**DEFENSE NUCLEAR FACILITIES  
SAFETY BOARD**

## Staff Report

May 6, 2021

### Savannah River Site H-Canyon Safety Basis Review

**Figure 1.** *Portable Air Compressor and Associated Equipment*

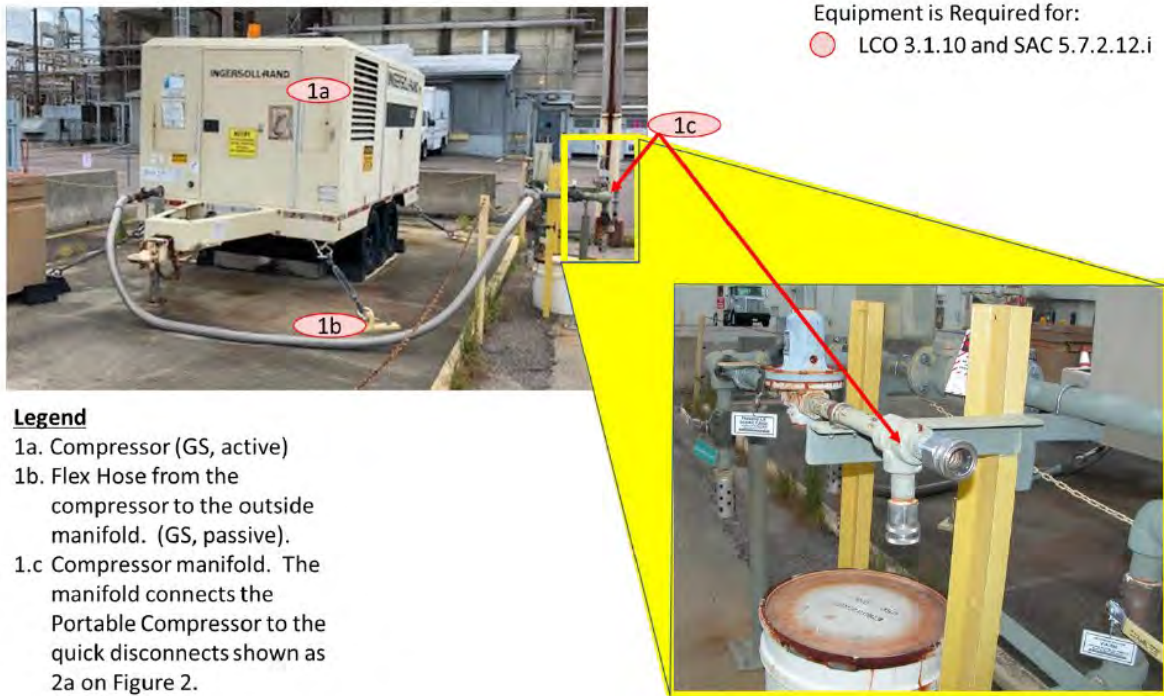
- During the discussions with the site personnel, DOE and SRNS representatives stated that although the portable air compressor is not designated as safety-significant, it is maintained under a preventative maintenance program (e.g., oil changes) and is started on a weekly basis, which increases the likelihood of identifying operability issues. Although the TSR requires periodic visual inspection and functional test of the system, not all the surveillance and maintenance requirements are identified in the TSR document since the air compressors are not designated as safety-significant. It is important to note that the site reported seven failures for the three seismic portable air compressors during their routine start up tests since 2014, mainly due to failed batteries or failed starters, based on the data provided during the discussions.

- According to site personnel, there are three portable compressors available to service the 32 process vessels after an earthquake, providing purge air to each in the order of their time to reach CLFL. Some of these vessels are expected reach the CLFL in less than 24 hours based on the contractor's analysis. The contractor believes that availability of three such systems will increase the reliability of having the capability to purge the vessels, as they can be moved around when any one is found to be inoperable after an earthquake. However, two of these portable compressors would have to be towed (see Figure 1 below) some distance (hundreds of meters), with the travel path potentially obstructed by debris and downed power lines in a post-seismic condition, creating an unpredictable and unreliable environment in which any mitigating action must be taken.

- The DSA contains planned safety improvements, and states: "Use of a stand-alone, seismically qualified vessel air purge system has been proposed to improve the control strategy for preventing an accumulation of flammable gases in the headspace of the canyon vessels following a seismic event. This would be a preventive SS control for design basis seismic events. As an interim control, the H-Canyon vessel air purge response (also referred to as the Seismic Event Response Program) is credited with preventing an accumulation of flammable gases in the vessels following a seismic event." It is not clear what DOE's plans are for implementing this proposed improved safety strategy to strengthen the reliability of the system and the safety posture of the facility.

**Figure 2.** *H-Canyon Exhaust Tunnel Layout* [2]

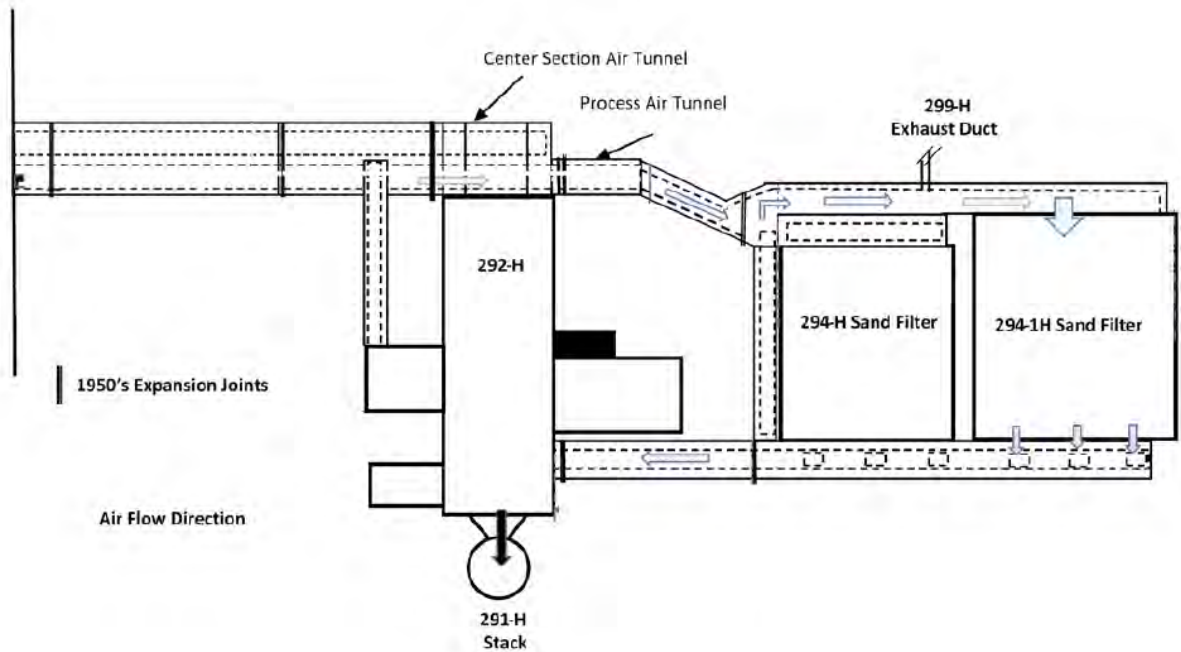
SRNS's analysis of the single and double tunnel configuration is technically defensible. However, if the tunnels are ever again credited to withstand the design basis seismic event, more sophisticated dynamic interaction analysis of the segments of the tunnels with adjacent facilities is needed. The fan house building, although a short and stout structure (i.e., essentially rigid from a dynamic perspective), would still be anticipated to impart inertial loads on the tunnel, particularly at the cross-over portion of the tunnel. Also, in this area the embedment of the tunnel is small and inertial effects may dominate over racking displacement loads. For the sand filter buildings, which neighbor significant lengths of the tunnels, complex soil-structure interaction response could be expected. These interactions would be between the sand filter structure, soil berms, the sand within the structure, and the neighboring tunnels; the current response of the sand filter buildings are based on simplified equivalent static methods.

The H-Canyon exhaust tunnels have experienced severe degradation in more than 60 years of use and this degradation will continue. DOE and SRNS should continue to monitor the condition of the tunnels and establish a firm timeline for both periodic re-inspection and eventual end of service. For the former, although the tunnels are currently credited as safety-class features for non-seismic events, the TSRs do not establish a required inspection periodicity of these design features. The TSRs do identify the SRS Structural Integrity Program as an administrative control; however, given that the tunnels are credited as safety-class for non-seismic accidents, an enforceable requirement for inspection periodicity is warranted.

A rigorous monitoring program is needed to not only observe degradation, but also detect wall movements that could be an indicator of the start of tunnel failure. This is particularly important since the current static analysis of the degraded tunnels [8] shows no margins for the code-based evaluations of ACI 349-13, *Code Requirements for Nuclear Safety-Related Concrete Structures* [9]. The staff team understands that three dimensional scans of the tunnels are planned, which will help supplement visual examinations and provide indications of worsening conditions. Based on the difficulties encountered during past remote inspections, future monitoring should include strategies to observe portions of the tunnel that are more difficult to observe, such as those obstructed by ductwork or hidden by tight corners. Lastly, since the static analysis of the tunnel indicates no margins when compared to code capacities, the staff believes SRNS should continue to enforce traffic restrictions over the tunnels to prevent unnecessary loading.
